TFA Ref: 20399

RE: (SSD-33042483) Environmental Impact Statement (EIS) Response for Stormwater Quality Requirements at Foreshore Road, Port Kembla – Described as Part of Lot 6 on DP1236743 and Lot 2 on DP1182823.

Please find below the responses to address items identified in the received assessment, advice and recommended conditions of approval for the aforementioned property dated 19th August 2022.

Figure A.2: MUSIC model schematic - Manildra Group – Port Facilities, Foreshore Road, Port Kembla NSW 2505

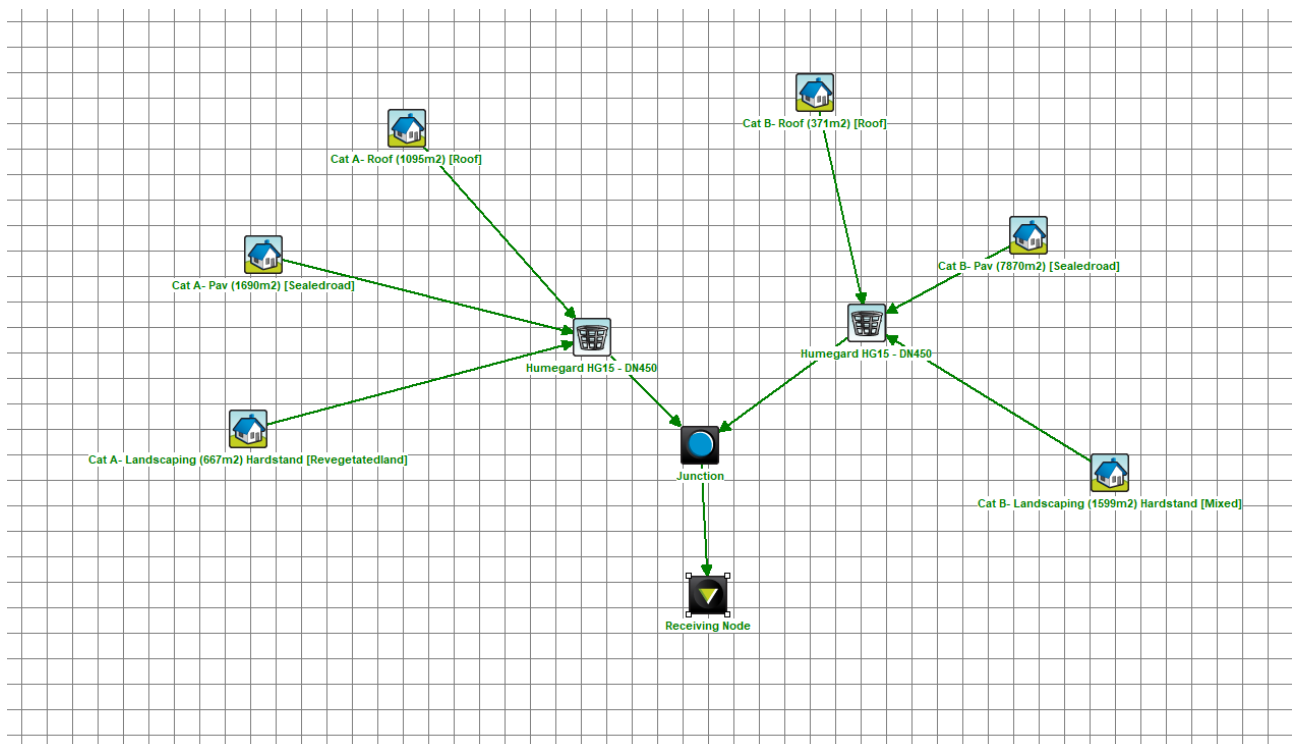
<p>8. Coastal Risk Management – Sea Level Rise and Flooding</p> <p>The EIS should consider the background condition of the receiving waterbody for the stormwater discharge and proposed monitoring to ensure stormwater management controls are affective.</p> <p>Recommended action:</p> <ul style="list-style-type: none"> Provide details of consideration of the background condition of the receiving waterbody for the stormwater discharge and proposed monitoring to ensure stormwater management controls are affective. 	<p>We note that the undeveloped site is characterised by unsealed surfaces/gravels and stockpiles with all the stormwater runoff flowing unmitigated into the existing channel running along the western side of the site. No defined lawful points of discharge are currently present and the current site conditions are likely to discharge significant amounts of sediment and suspended solids into the receiving waterbody.</p> <p>The proposed development will delineate drainage catchments, seal the surfaces, convey stormwater runoff through a piped network and ultimately treat the water before is discharged into the receiving waterbody via defined lawful points of discharge. The implementation of these water sensitive urban design measures will ensure that there is no-worsening of the pre-development conditions.</p> <p>Furthermore, all the proposed stormwater treatment devices will be monitored and maintained strictly in accordance with the manufacturer’s recommendations to ensure their adequate operation. Section 6 of the previously submitted SBSMP provide details of the required maintenance procedures and frequency.</p> <p>If required, monitoring of the stormwater quality prior to discharge can be implemented downstream of the stormwater quality improvement devices.</p>

The proposed stormwater treatment train modelled in MUSIC consists of a Hume Gard HG15 for both catchments A and B. Figure A.2 below shows a schematic representation of the models analysed and Table A.3 demonstrates that the pollutant load reduction objectives for the site have been achieved, i.e. the treatment methods proposed are adequate.

The proposed stormwater treatment measures were modelled in MUSIC and the results of MUSIC modelling are as shown in Table A.3 and Table A.4 respectively.

Table A.4 above, demonstrates that the pollutant load reduction objectives for the site have been achieved, i.e., the treatment methods proposed are adequate.
